# Technical Note

25<sup>TH</sup> MARCH 2020

**TY CROES SOLAR FARM: ADDENDUM TO YELLOW SUB GEO COAL MINING RISK ASSESSMENT REPORT, REF. 19158\_R1 DATED DECEMBER 2019**

**Figure 2 Shaft location in the land near the A48.**

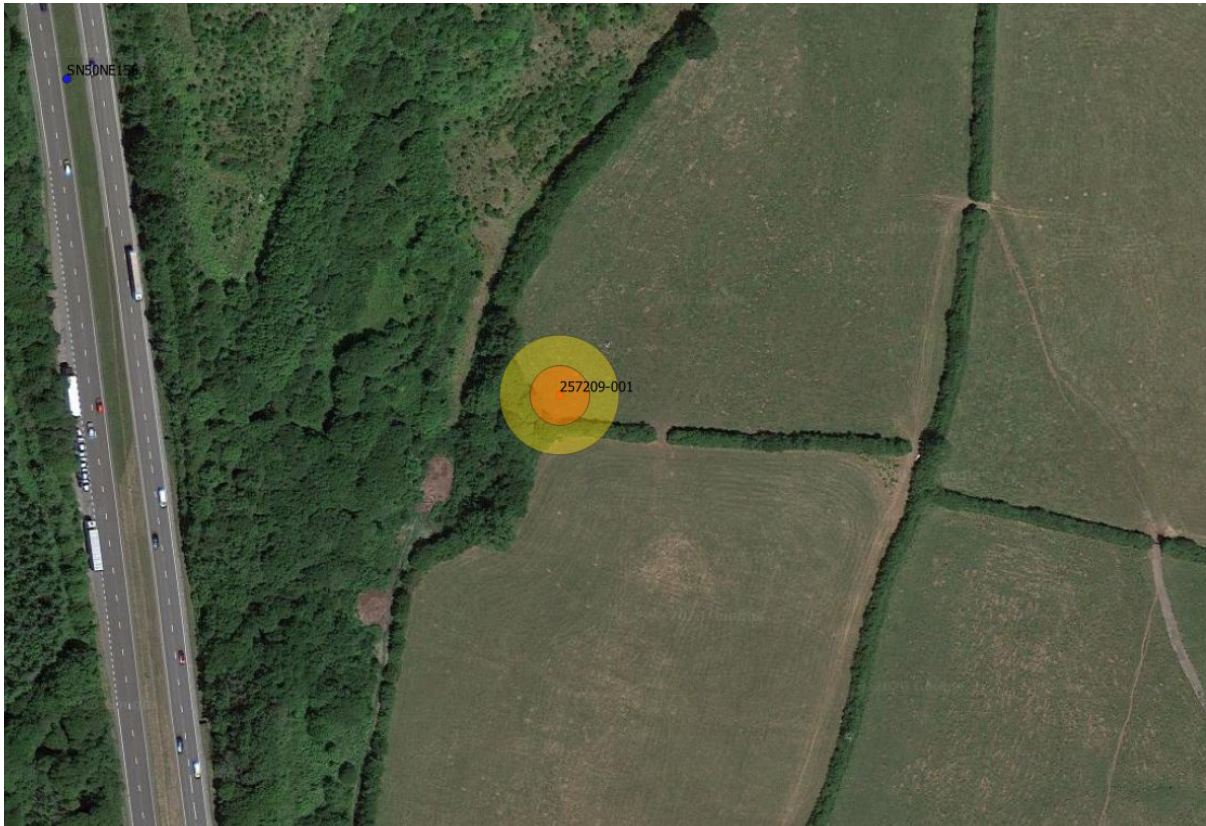
In Figure 2 the red dot for the shaft indicates the grid reference provided by the CA. The orange shaded circle represents an approximate 10 m radius departure area, reflecting the typical allowance required to reflect uncertainty in extrapolating this position from the historical plans.

The nearest historical borehole, taken from the British Geological Survey archives (indicated by blue circle in the top left corner of Figure 2), indicate a superficial soil thickness of 4.4 m (see Annex C). Taking a depth to bedrock of 5 m and an assumed angle of repose upon collapse of 1:2, this suggests a further 10 m radius zone of influence should be allowed for. This is the shaded yellow outer circle in Figure 2.

In response to this potential constraint, the panel layout in this area has been stepped out to ensure that no panels are proposed within the 20 m radius zone of influence from shaft 258209-001 at NGR 257333 209569. Fence posts for the security fence shall be installed using hand tools only within the yellow shaded zone of influence.
